DEALER BULLETIN

SLR/011/00

17 MAY 2000

TECHNICAL BULLETINS

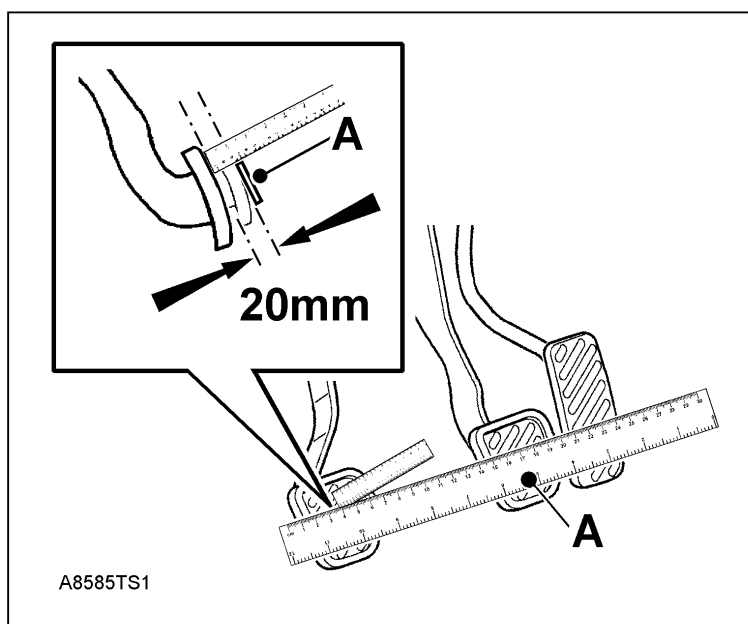
Insufficient travel in the clutch release mechanism to permit full disengagement of the clutch.

1. Place a rule or similar straight edge on the centre of the brake pedal pad, ('A' in illustration). Ensure that the rule extends across the clutch pedal pad as shown.

2. With a second rule positioned at right angles to the clutch pedal pad, measure the distance from the underside of the first rule to the surface of the clutch pedal pad. The maximum acceptable distance is 20mm, (see inset in illustration).
 3. If the measurement exceeds 20mm, fit new clutch pedal assembly part number SUB100240.
-

SUB100240 Pedal assembly - clutch

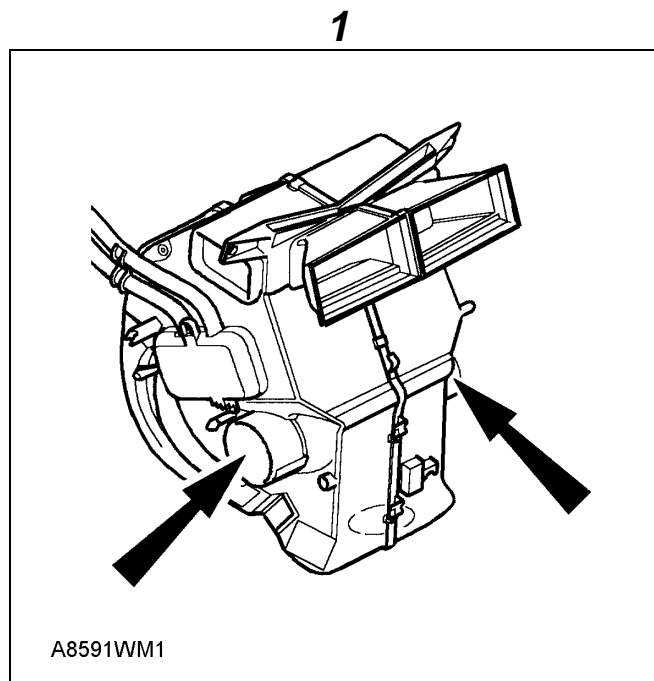
Either or both heater to front screen demist ducts adrift from heater.

1. From the footwell area, examine the point where the left hand and right hand demist ducts attach to each side of the heater, (arrowed in illustration 1). If either or both are adrift from the heater, use the following procedure to ensure security of the duct when refitted.

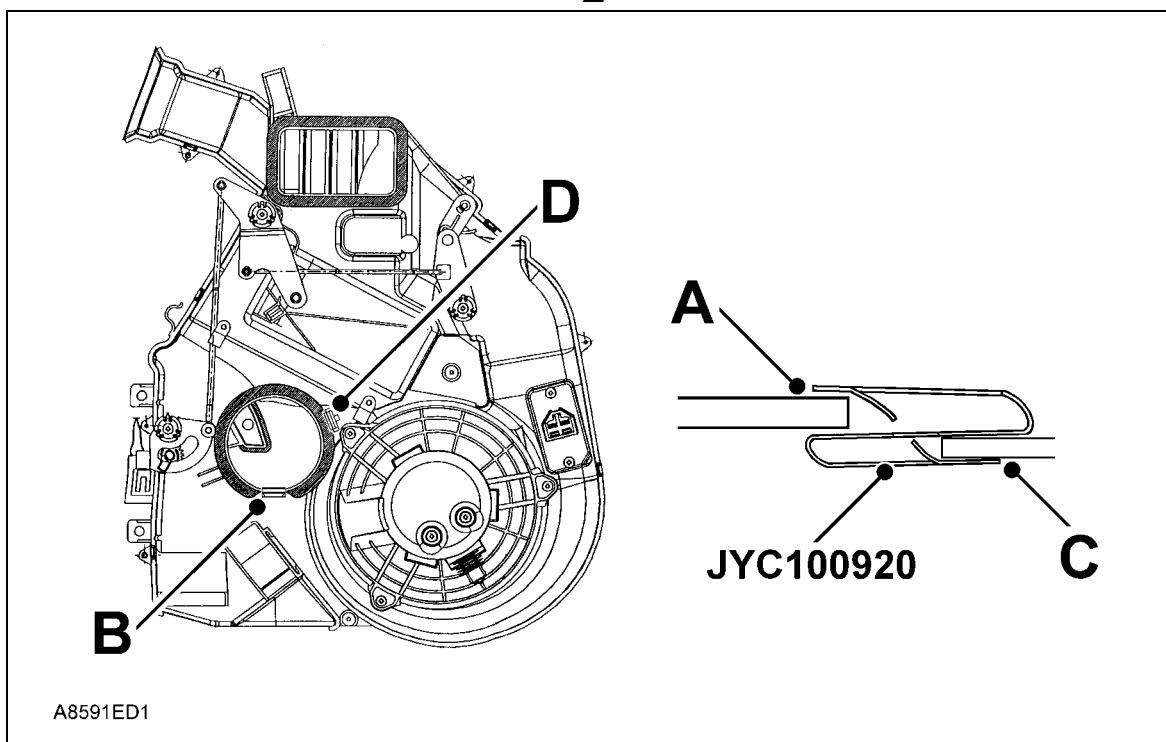
2. Working from the footwell area, carefully move the duct away from the heater to enable additional latching clip JYC100920 to be positioned.
3. Identify the wider opening of clip JYC100920, ('A' in illustration 2). Fit the wider opening of the clip to the heater demist outlet at the 6 o'clock position, ('B' in illustration 2), so that the narrower opening of the clip is outside the circumference of the outlet in readiness to receive the demist duct, ('C' in illustration 2).

4. Push the clip fully home over the foam gasket on the demist outlet.
5. Reconnect the duct to the demist outlet ensuring that the duct locates fully into the narrower opening of JYC100920 and that the integral latching clip on the heater casing, ('D' in illustration 2) is outside the duct and latched to it.

JYC100920 Edge clip - 2 per vehicle
